**SUBJECT:** Transmittal of Revised Responses to AP1000 DSER Open Items

AP1000 Design Certification Review  
Draft Safety Evaluation Report Open Item Non-Proprietary Responses

DSER Open Item Number: 2.3.4-1 Revision 2

DSER Open Item Number: 3.8.4.5-2 (Response Revision 2)

Figure 15A-1

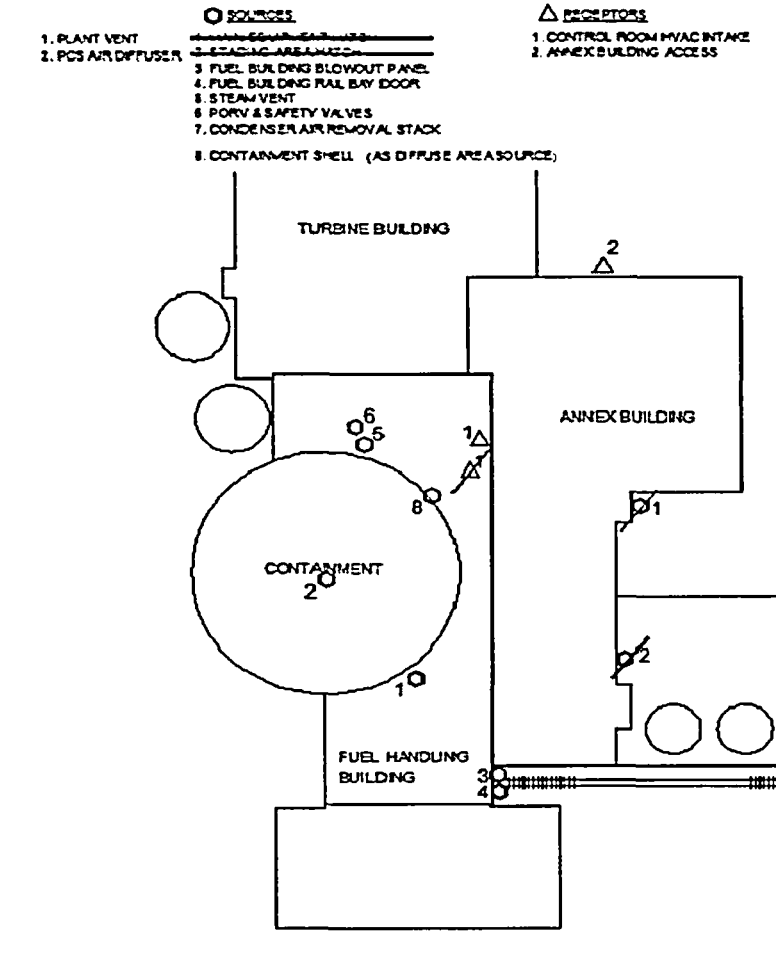
Westinghouse submitted revisions to address this question in DCD Revision 7. The staff had further questions in response to those revisions, particularly relating to the modeling used in the demonstration case control room  $\chi/Q$  values.

The ARCON96 modeling approach used (as illustrated in attached DCD mark-up, Table 15.A-7 and Figure 15A-1) is fully in compliance with Regulatory Guide 1.194.

1. Bounding control room  $\chi/Q$  values will be established for the AP1000. These values will be determined for the various source – receptor locations that are applicable for the various design basis accidents as appropriate.  $\chi/Q$  values that will still yield doses within the dose acceptance limits will be calculated consistent with the dose analysis methodology and assumptions described in the DCD Chapters 6 and 15. Consistent with the approach of treating the control room  $\chi/Q$  values as interface parameters, Westinghouse will revise some assumptions described in the current DCD dose analysis to remove excess conservatism to provide the COL applicant greater flexibility in demonstrating acceptability. These changes were incorporated in DCD Revision 7; minor additional changes are provided in the attached DCD markup and will be included in DCD Revision 8.

3. A set of  $\chi/Q$  values for typical site meteorology and plant orientation have been calculated in accordance with the guidance set forth in Regulatory Guide 1.194. The purpose of the calculation is to define the modeling assumptions for calculating the control room  $\chi/Q$  values for AP1000, and will serve as an example of an approved method for the COL applicant to follow to determine the acceptability of their site to meet the control room  $\chi/Q$  values. Relevant portions of this calculation are now included in DCD Appendix 15A.

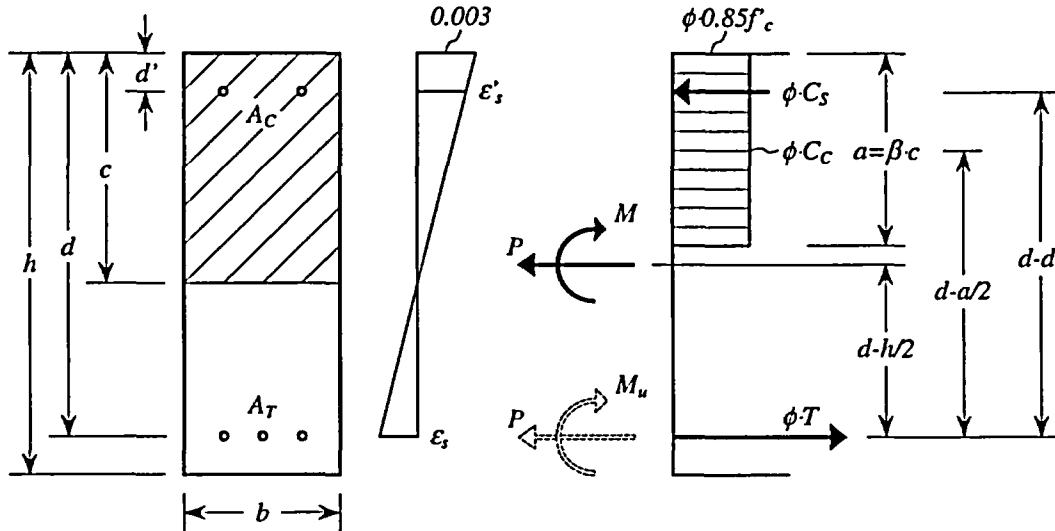
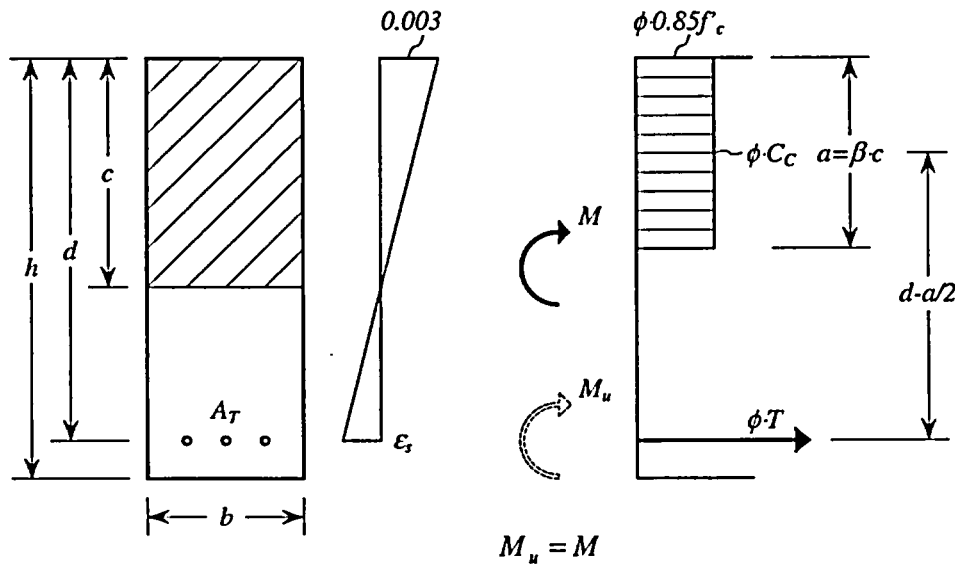
During the course of its review of the Wall 7.3 design calculation, the staff noted that the applicant had previously identified and corrected an error in the equation used by INITEC to calculate the required positive reinforcement for a section subjected to both bending moment and axial load. The staff could not conclude during the audit that the corrected equation accurately calculates required positive reinforcement. Therefore, the applicant was requested to submit the derivation of the equation currently used to calculate the required reinforcement. The applicant was also requested to submit a sample verification calculation for the computer algorithm, and verify that the corrected equation has been utilized in all calculations. This is Open Item 3.8.4.5-2.

The development of the equation for sizing the required reinforcement for a section subject to bending moment and axial load is shown in this response. This equation is applicable when the strength of the section is controlled by yielding of the tension steel and both tension and compression steel, if any, are at yield. Loads and internal forces are shown in the following figures. The design loads  $P$  and  $M$  act at the centroid of the section, where:

The strength reduction factor  $\phi$  is applied to both the steel and concrete strengths to obtain the design strength as shown in the figures.

Figure 3.8.4.5-2-1  
Axial Load-Moment Interaction Diagram

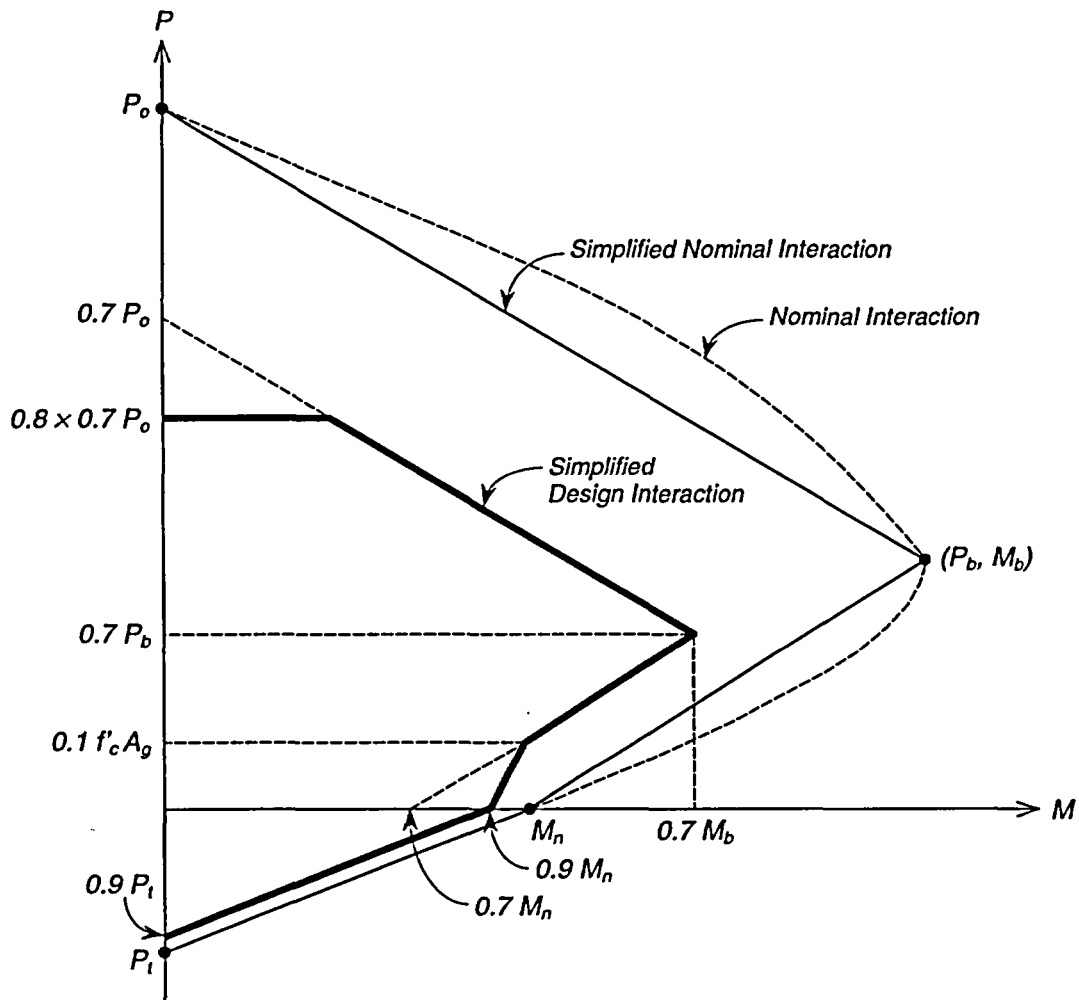
The Revision 0 response only showed development of equation for one case (axial plus bending with both tension and compression steel at yield). Clarify how range of applicability is checked and what other cases are used in the macro or explain how design engineer is told that the case is out of range of applicability.

Confirm that the guidance described in revision 1 of this response has been implemented in the design of the critical sections.

Figure 3.8.4.5-2-1 shows a typical interaction diagram defining the strength of a concrete section under combined axial force ( $P$ ) and bending moment ( $M$ ). It shows the nominal strength interaction as well as a simplified nominal interaction based on straight lines connecting the following key points:

Guidance is being provided to the engineer to perform an additional check when the axial compressive forces are greater than  $\phi P_b$ . In this additional check the axial load-moment interaction diagram is calculated for the reinforcement that has been selected based on use of the macro. Combinations of design moments with axial forces greater than  $\phi P_b$  are reviewed and confirmed to be bounded by the interaction diagram.
